MONUMENT RIDGE EAST FILING NO. 1

CONSTRUCTION DRAWINGS

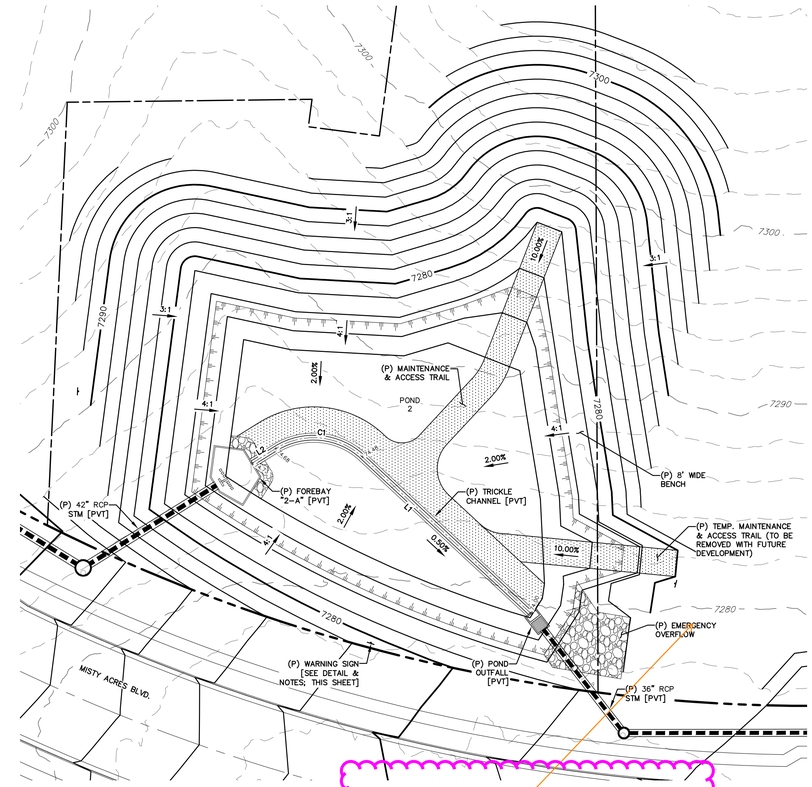
Unresolved previous comment:
Provide pond maintenance access easement and the road itself from the bottom of the pond up the embankment and to a public road, per DCMv1, Chap 11.2.2.

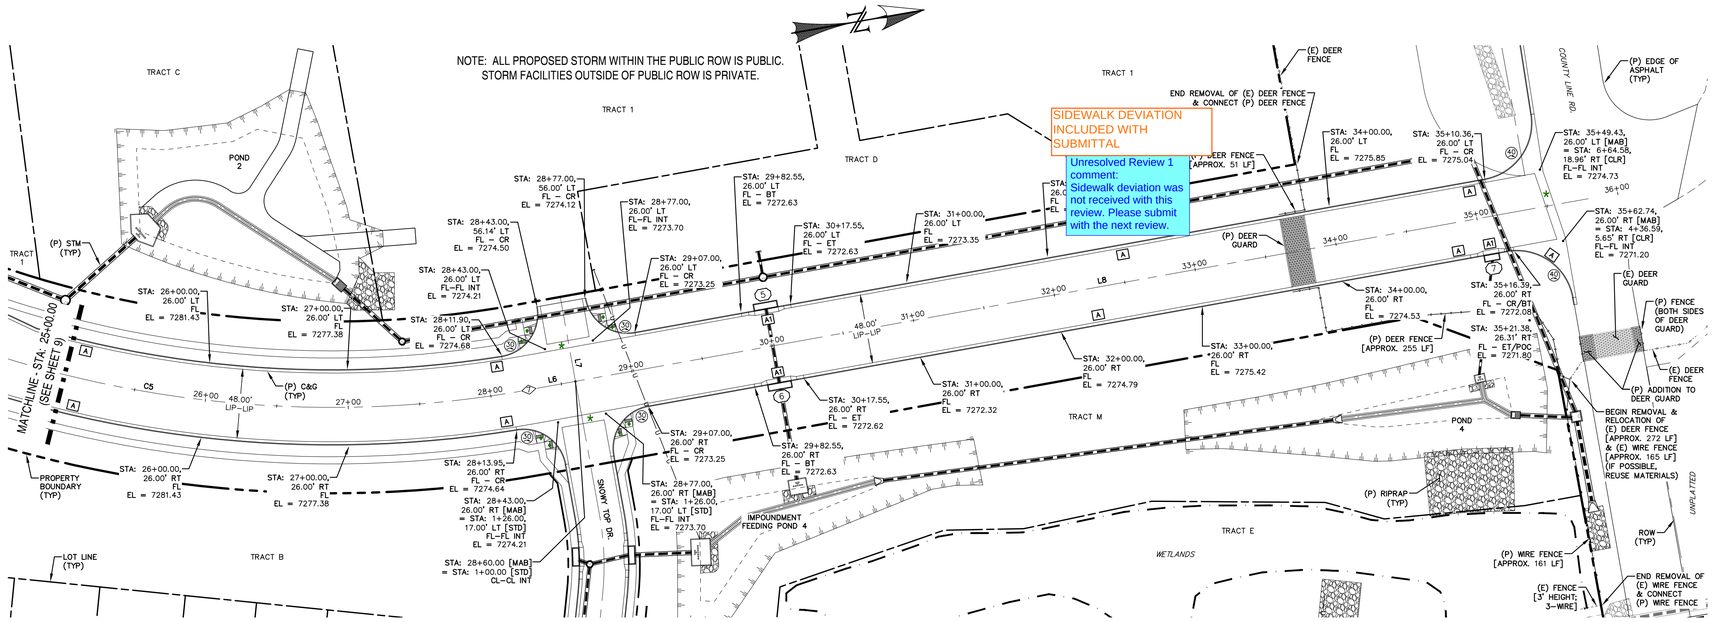
Unresolved Review 1 comment:
Sidewalk deviation was not received with this review. Please submit with the next review.
